April 28, 2021

RE: Comments on proposed MUTCD section 9E.14, "Bicycle Route Pavement Markings"

Figure 3. Left: Unstretched pavement marking and marking with 2:1 stretch. Right: Same markings as viewed from 20 feet away and 5 feet off the ground.

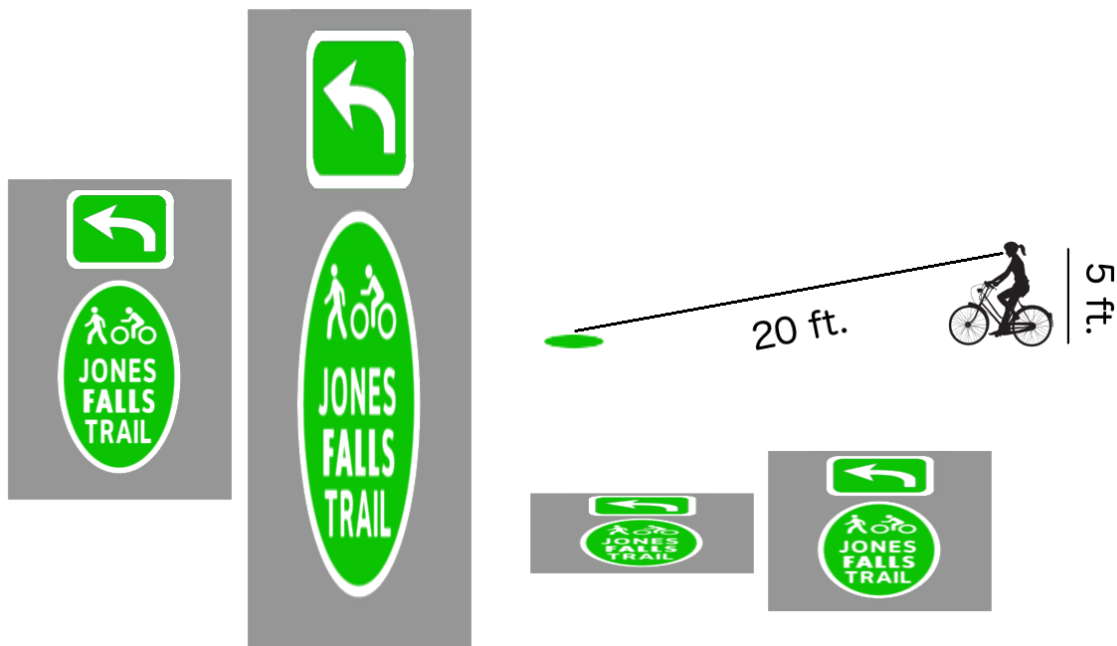
4) The proposed Guidance in section 9E.14 includes the sentence:

"The route marker pavement marking should not be elongated."

I assume this is a typo and should read "should be elongated," because the bicycle route pavement markings shown in Fig. 9E-15 are elongated; all the other pavement markings (lane markings, arrows, bicycle detector marking) shown in Figs. 9E-1 to 9E-16 are elongated; and it makes sense to elongate bicycle pavement markings for the same reason that car-directed pavement markings are elongated, to counteract the foreshortening caused by viewing at a low angle.
